Access Compliance Report

Public Rights-of-Way

Intersection ID: 10022821	Main Street: CASTLE_WATCH_AV	Cross Street: N/A	Location: NW
ADA ID: E2700CB1F13D	Ramp Type: PerpDiag	Initial Pass/Fail: Fail	Overall Compliance: No
			Severity Score: 33.75

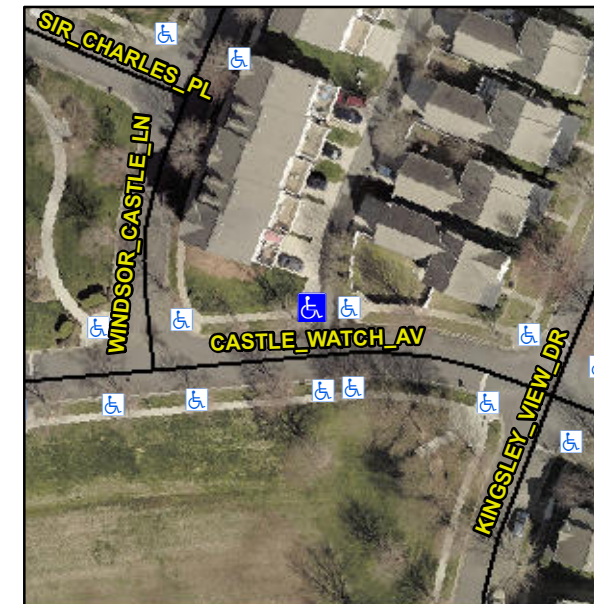
Not Found, R304.5.1, R304.5.3

Compliance	Description	Data	Compliance	Description	Data
N/A	Ramp Length (in)	76.0	Yes	Ramp Slope (%)	5.8
No	Ramp Width (in)	39.0	No	Ramp XSlope (%)	7.8
N/A	Flare Type LT	N/A	N/A	Flare Type RT	N/A
N/A	Flare Slope LT (%)	N/A	N/A	Flare Slope RT (%)	N/A
N/A	Flare Traversable LT?	N/A	N/A	Flare Traversable RT?	N/A
N/A	Landing Length (in)	N/A	N/A	DWS Provided?	N/A
N/A	Landing Width (in)	N/A	N/A	DWS Contrast?	N/A
N/A	Landing Slope (%)	N/A	N/A	DWS Length (in)	N/A
N/A	Landing X Slope (%)	N/A	N/A	DWS Full Width?	N/A
N/A	Landing Curb? (Y/N)	N/A	N/A	DWS Offset (in)	N/A
N/A	Shared Landing?	N/A			
N/A	Gutter Ponding?	N/A	N/A	Gutter Slope (%)	N/A
N/A	Gutter Lip Ht (in)	N/A	N/A	Gutter X Slope (%)	N/A
N/A	Painted X Walk1?	No	N/A	Painted X Walk2?	No
	X Walk 1 Direction	To S		X Walk 2 Direction	To E
N/A	X Walk 1 Width (in)	N/A	N/A	X Walk 2 Width (in)	N/A
	X Walk 1 Slope (%)	0.4		X Walk 2 Slope (%)	2.8
	X Walk 1 X Slope (%)	3.3		X Walk 2 X Slope (%)	2.7

Remove & Replace Curb Ramp With Two New Directional Ramps or Equivalent.
